345 12TH PL N

ENGINEERING & PUBLIC WORKS PROJECT REVIEW CHECK LIST

MEMO TO: Building Division
Planning Department

SUBJECT: 345 12TH PL N

SITE PLAN, SCALE: 1" = 30'

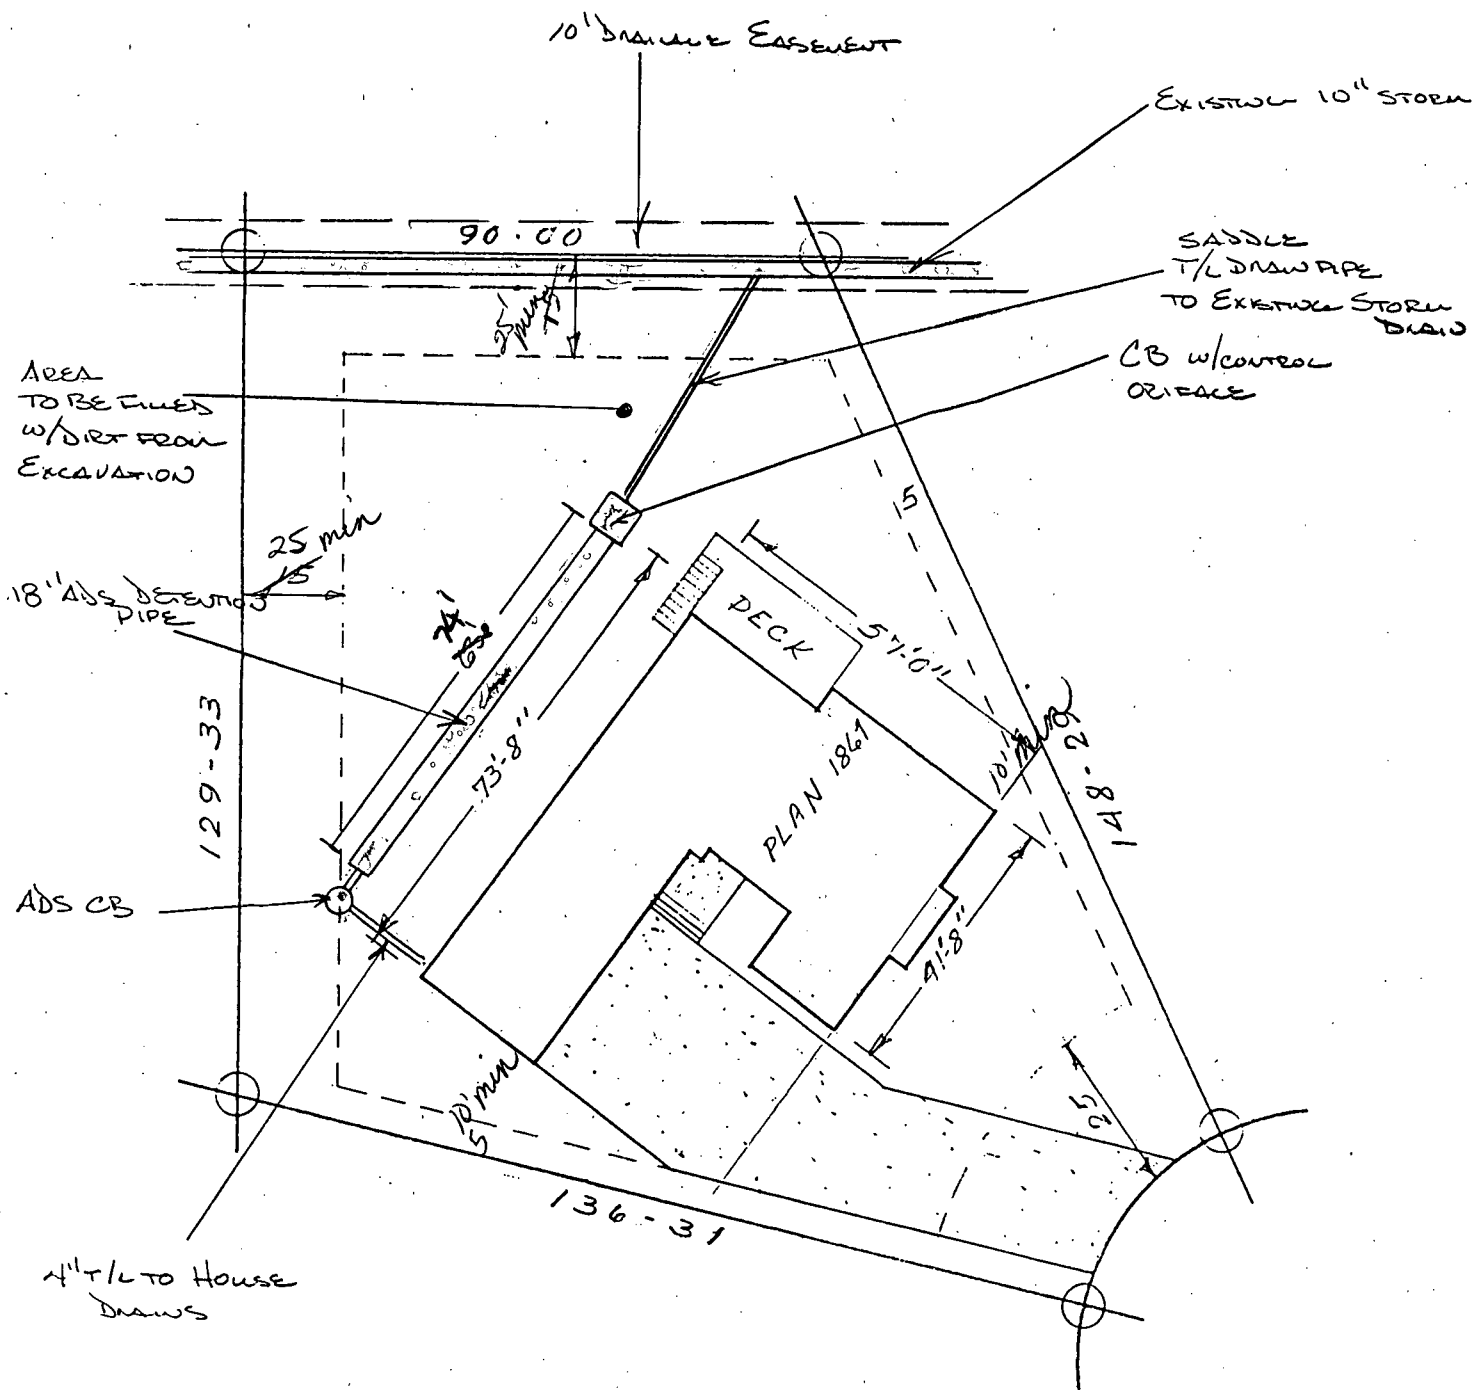
* SEE DETAIL
✓ J. Hantle 11/4/84

STANDARD DRAINAGE PLAN

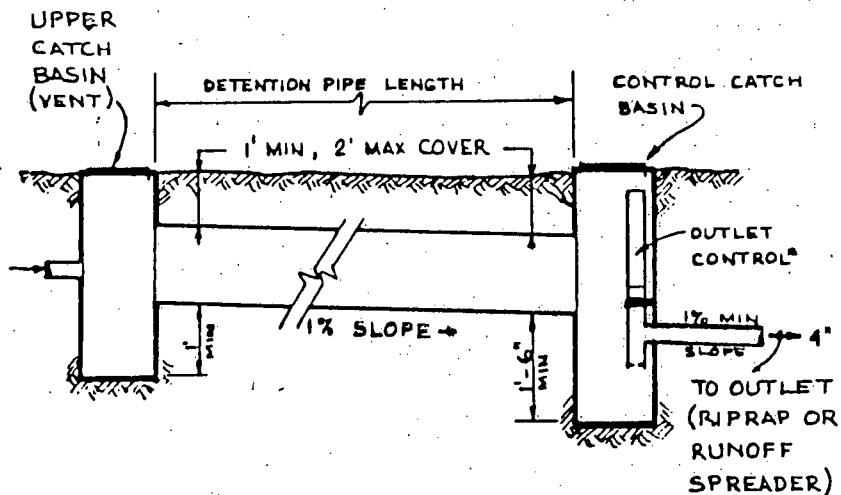
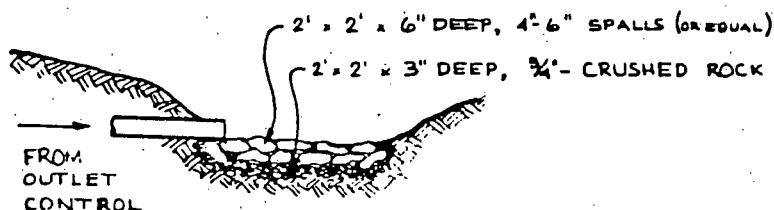
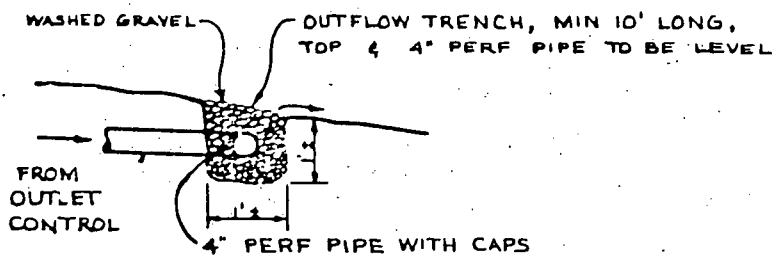
* See Detail
J. Hawth 11/14/84
